1984 Corvette: Recall: Rear Axle Differential Cross Shaft Retention

Subject: REAR AXLE DIFFERENTIAL CROSS SHAFT RETENTION

Model and Year: 1984 CHEVROLET CORVETTE MODELS

Bulletin Number: 84-C-25 - (09/20/1985)

FIGURE 1

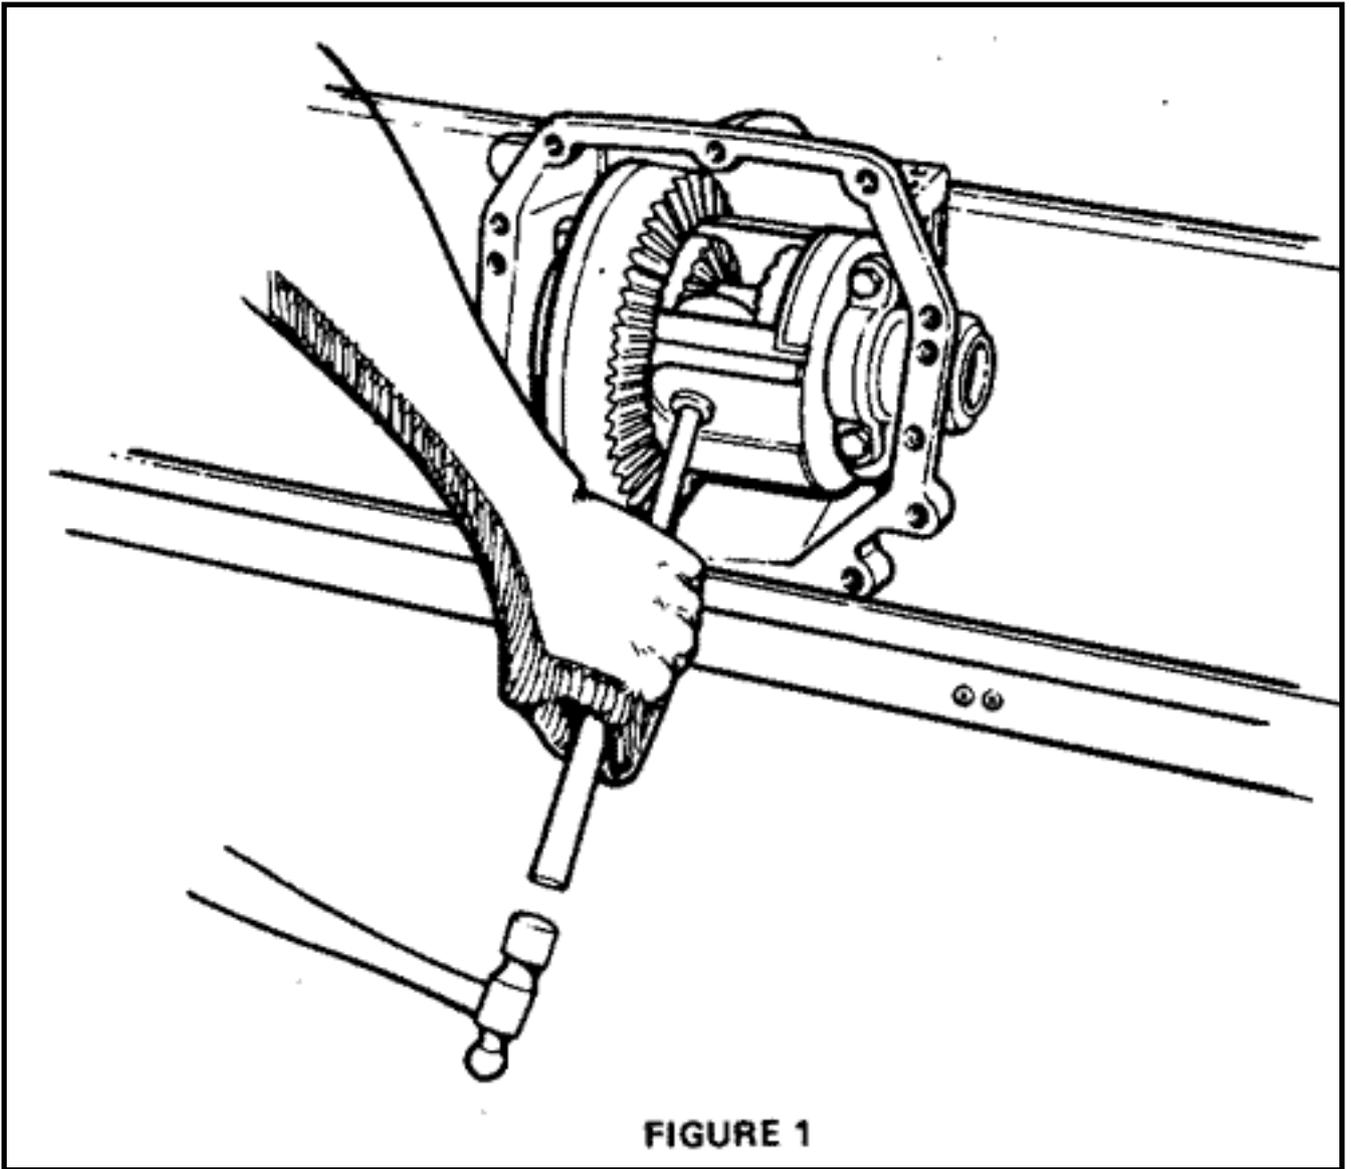
5. Rotate case assembly to position illustrated in Figure 1. With appropriate size drift and small mallet, lightly tap on cross shaft to determine if movement of shaft can be achieved.

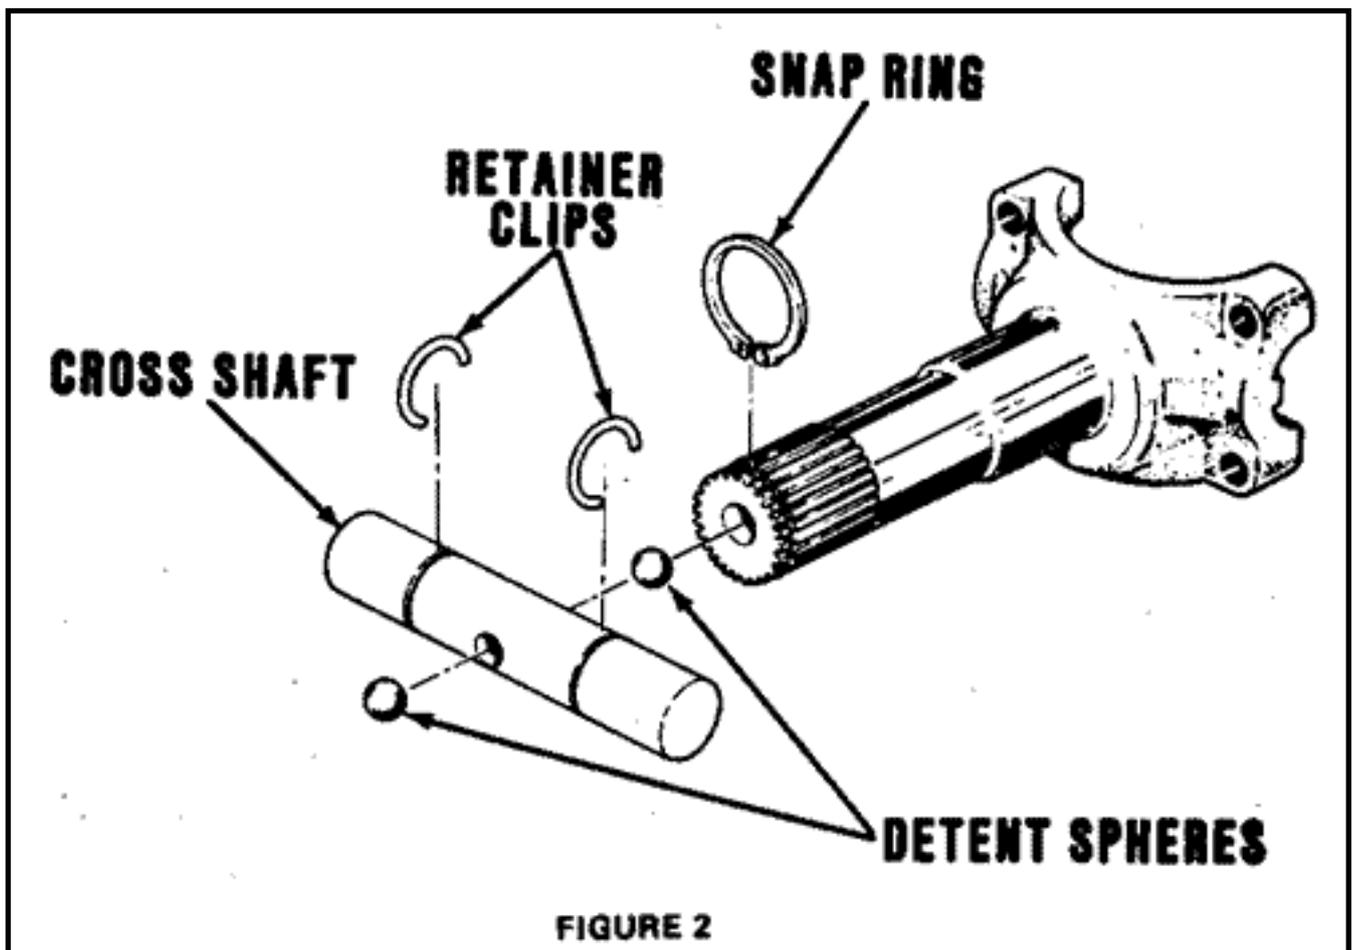
Tap cross shaft inboard approximately 1 1/4 inches and rotate case 180 DEG. Utilizing vise grips and a back and forth motion, remove shaft. Install new cross shaft insuring detents in the shaft are positioned properly to accept spheres (balls) to be installed, between shaft and output yokes as illustrated in Figure 2.

Remove case assembly from carrier following appropriate procedure in 1985 Corvette Shop Manual. Press existing cross shaft out of case and install new cross shaft insuring detents in the shaft are positioned properly to accept spheres (balls) to be installed between shaft and output yokes as illustrated in

Figure 2. Reinstall case assembly following appropriate 1985 Shop Manual procedure.
